**ADDENDUM NO. 1**

**Alder Avenue  
WORK ORDER: H14978  
AREA: Fontana  
ROAD NO.: 160050 040-050**

## ADDENDUM NO. 1 – ALDER AVENUE

ALDER AVENUE				
CURB RETURN DETAILS				
FONTANA AREA				
J.L. REF.	W.O. NO.	PLAN SCALE	SHT. NO.	TOT. SHT'S
JL 11641	H14978	1"=20'	8	13

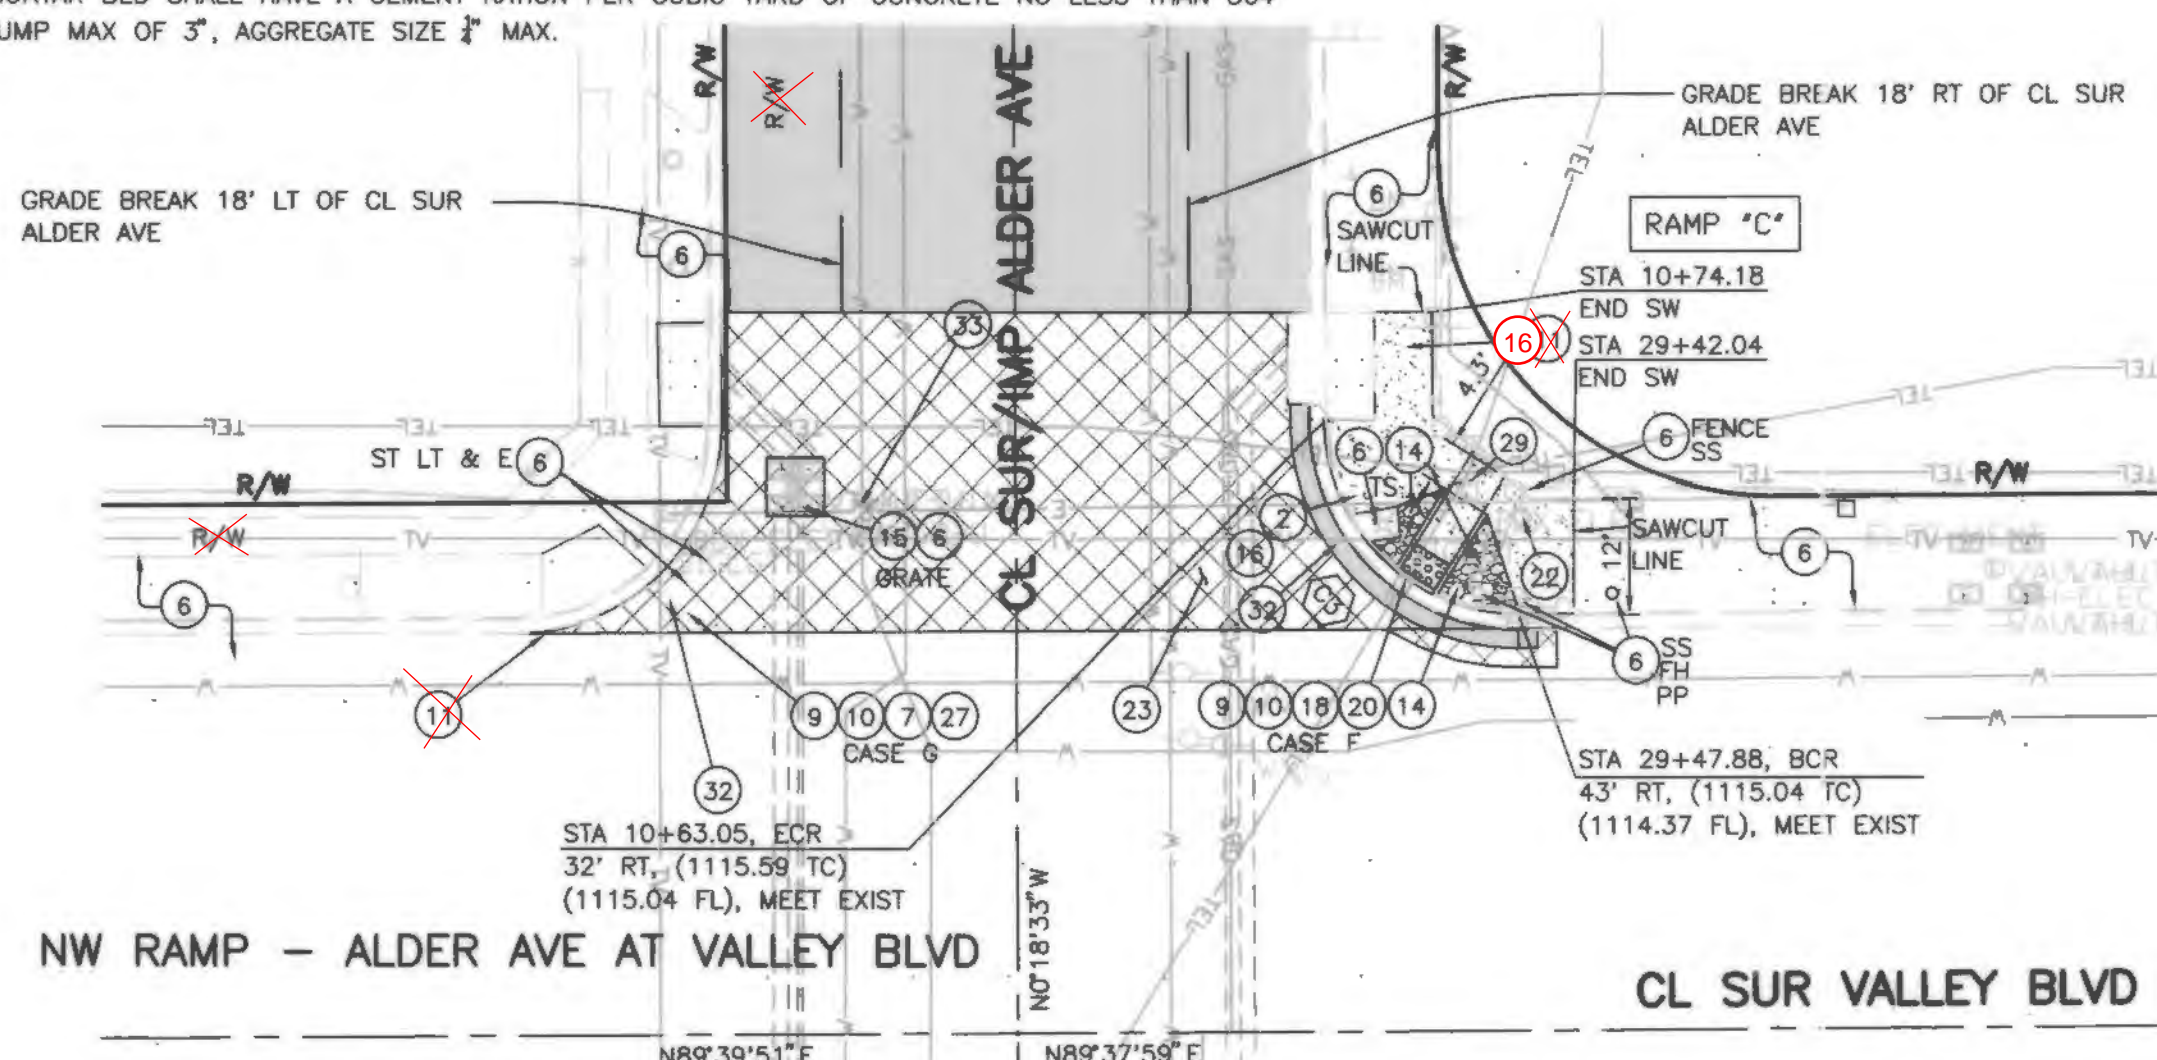
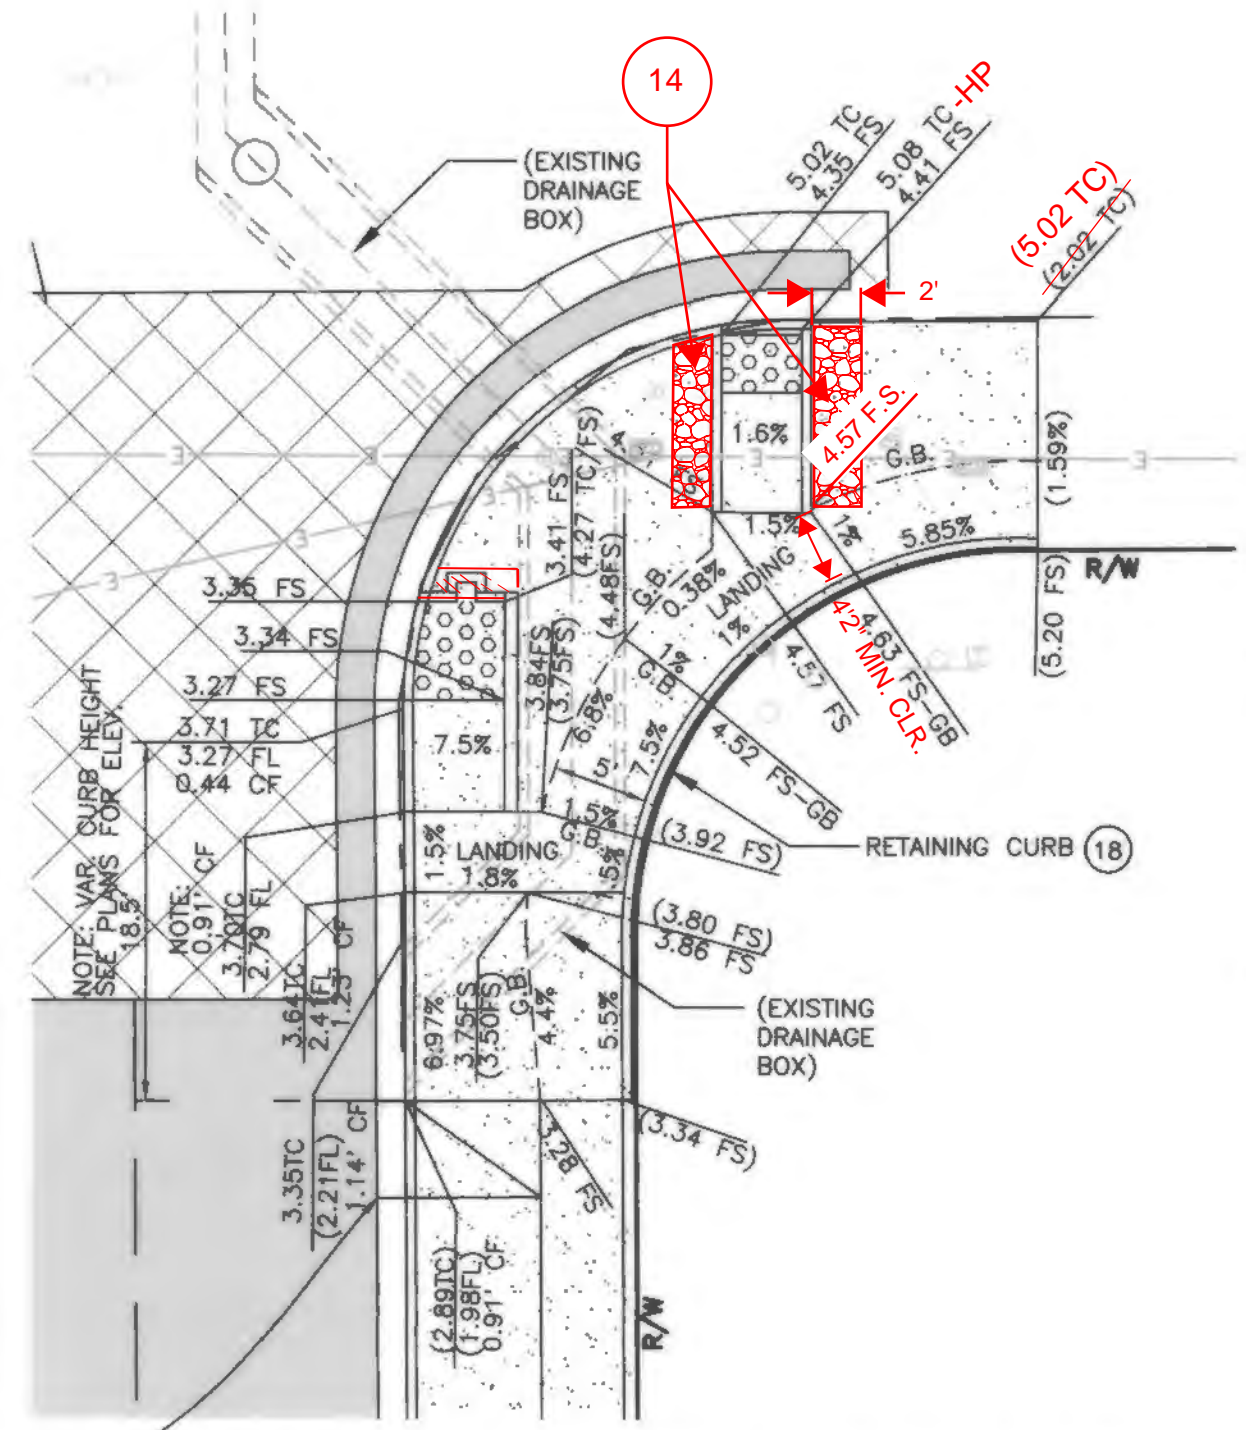
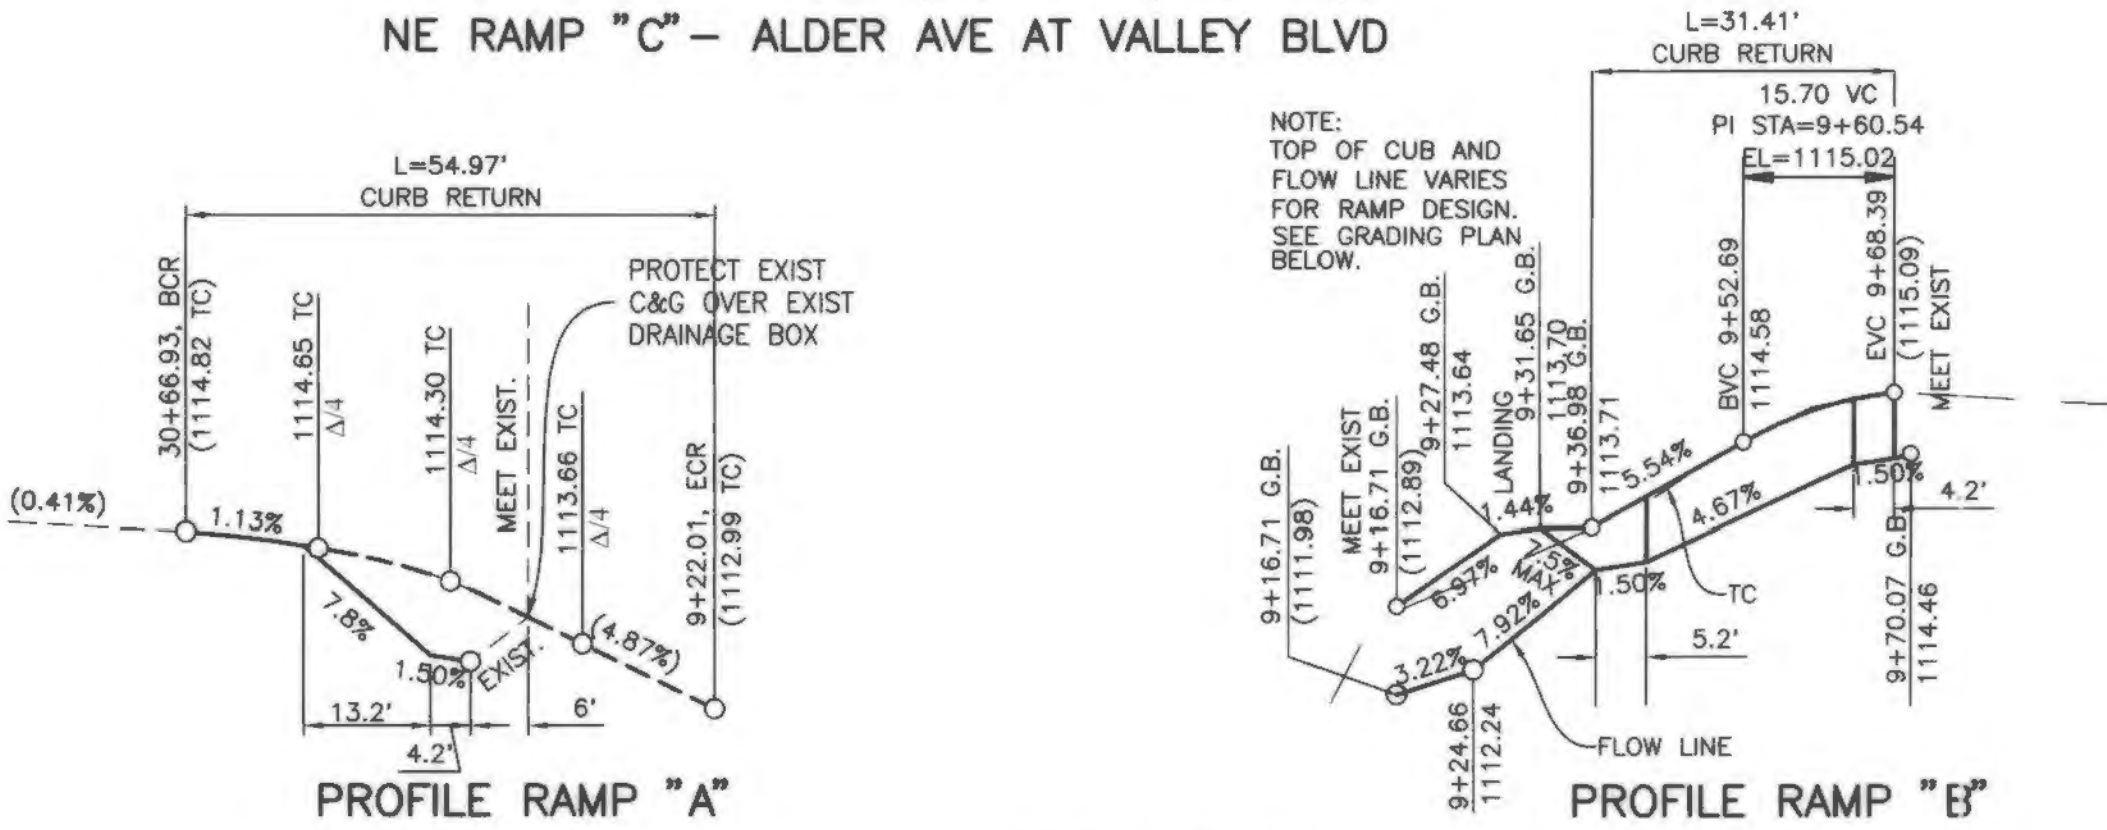
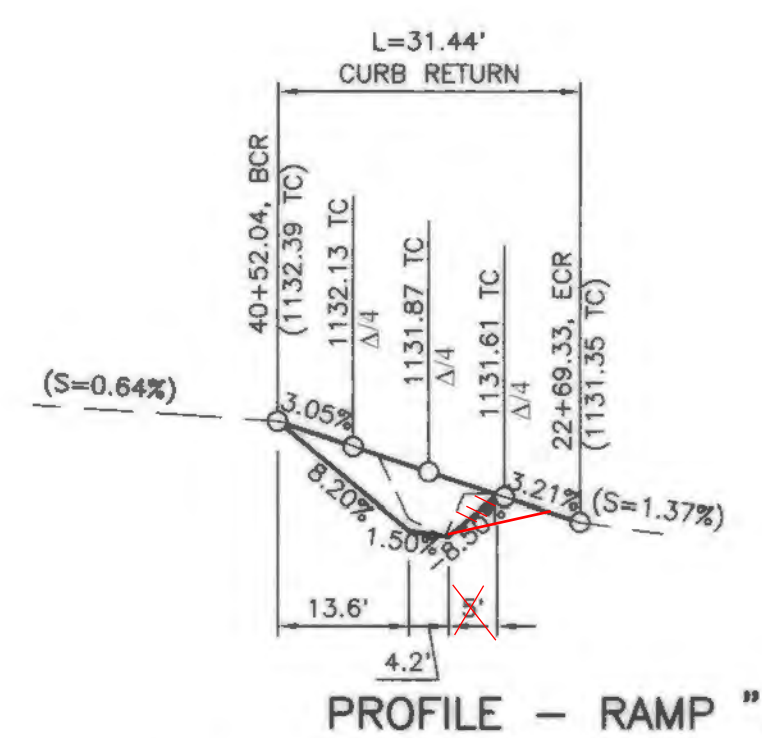
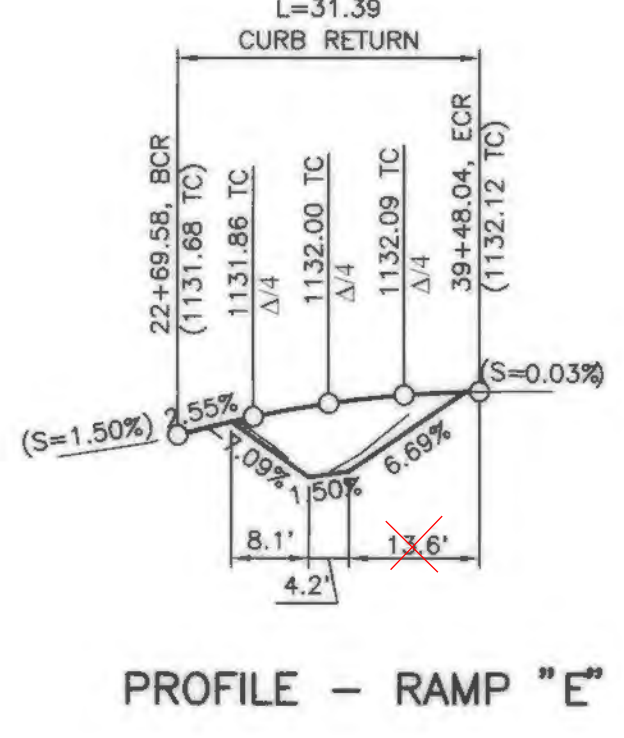
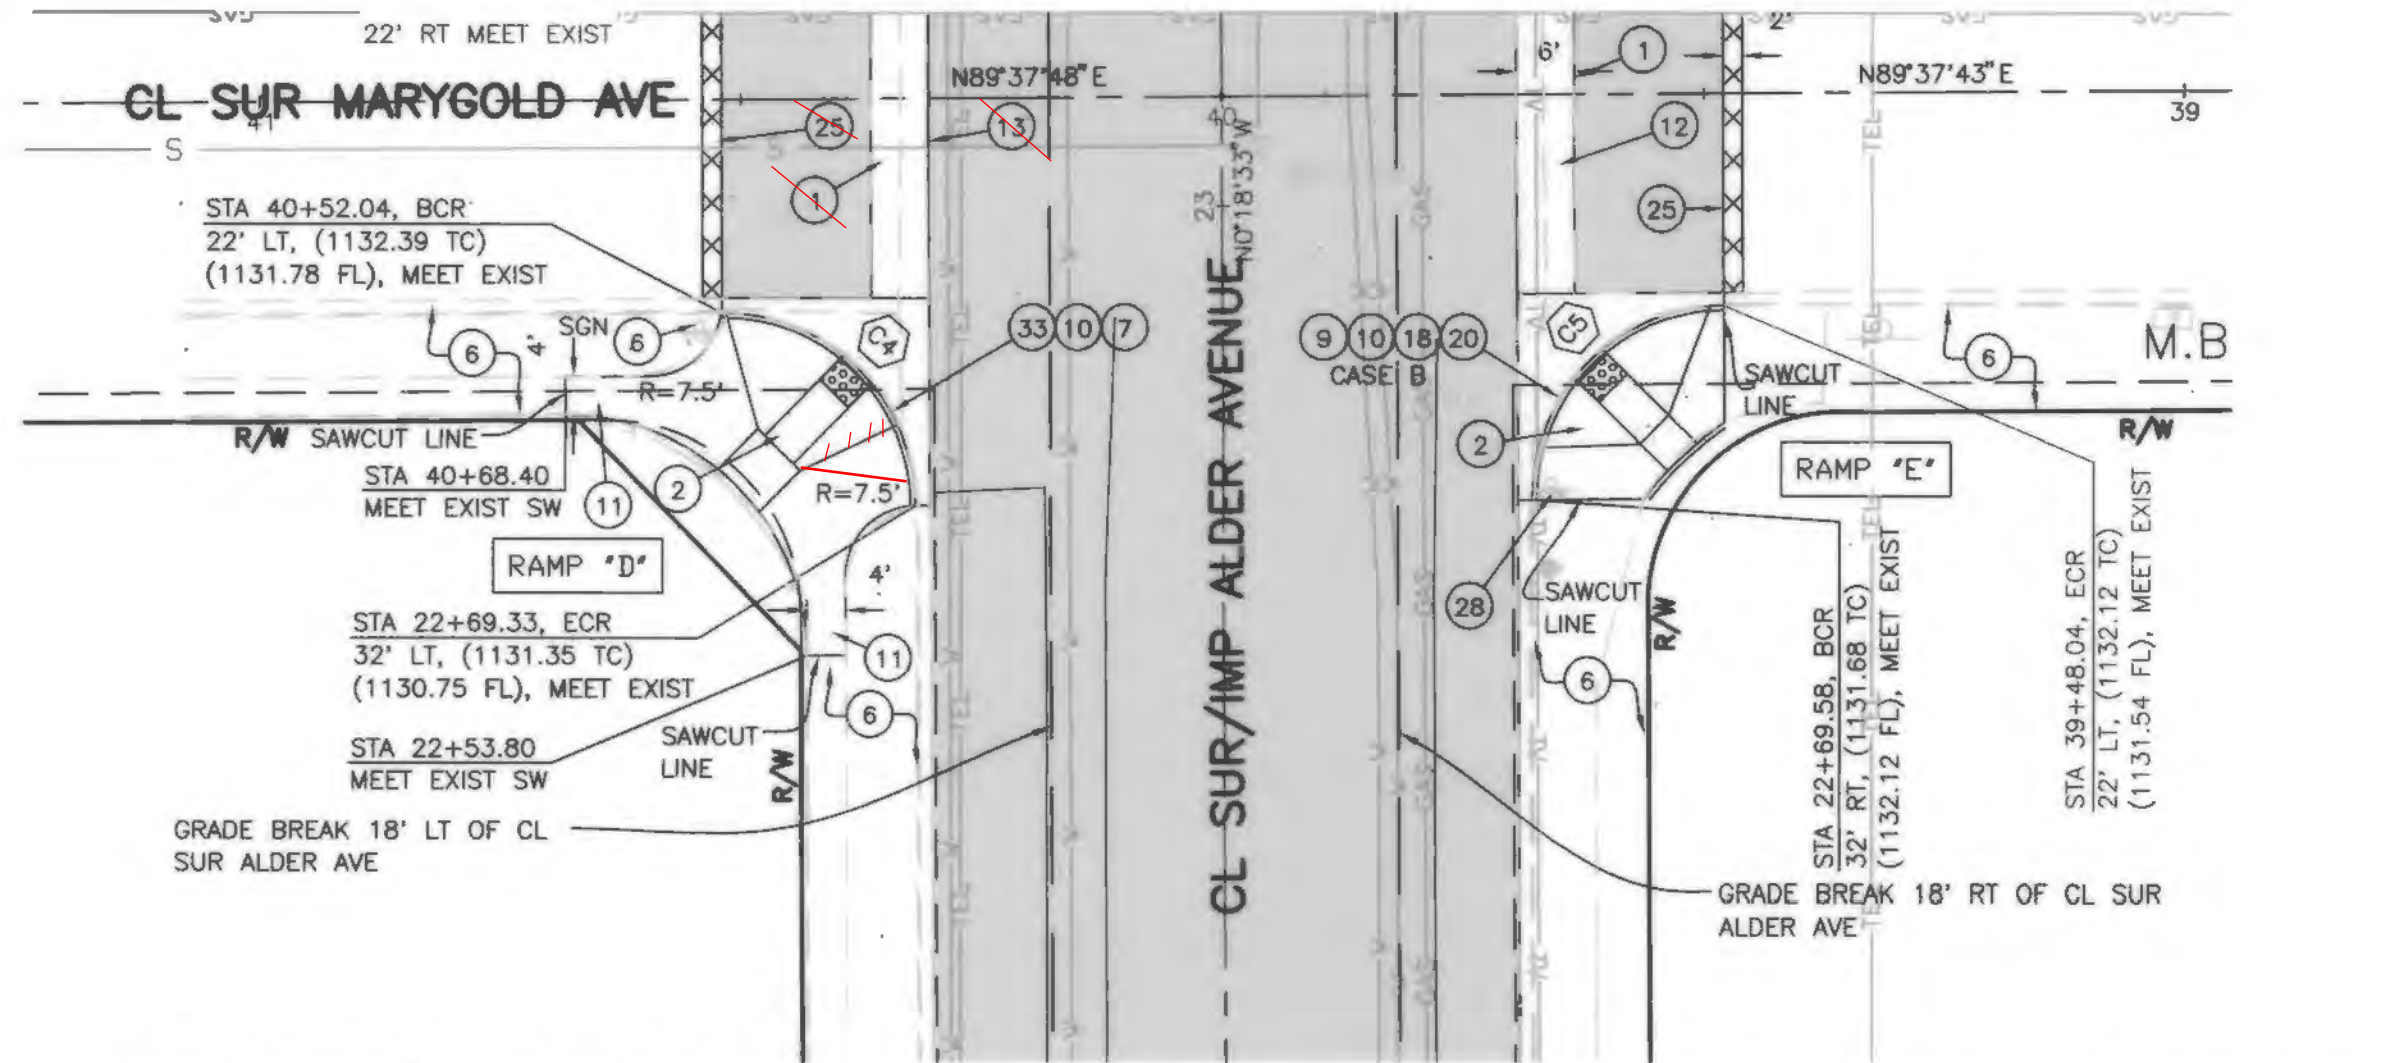
1. Sheet 3 of 13:  
Delete Sheet 3 of 13 and replace with Sheet 3 of 13
2. Sheet 8 of 13:  
Delete Sheet 8 of 13 and replace with Sheet 8 of 13
3. Sheet 12 of 13:  
Delete Sheet 12 of 13 and replace with Sheet 12 of 13
4. Sheet 13 of 13:  
Delete Sheet 13 of 13 and replace with Sheet 13 of 13

1. Revised Sheet 3 of 13, Alder Avenue – Typical Cross Sections;
2. Revised Sheet 8 of 13, Alder Avenue – Curb Return Details;
3. Revised Sheet 12 of 13, Alder Avenue at Valley Boulevard - Traffic Signal Modification Plan;
4. Revised Sheet 13 of 13. No revisions, re-scanned to improve clarity;
5. Revised Bid Item Sheet. Replace proposal page P-3 and P-4 with the attached revised sheet P-3 and P-4.
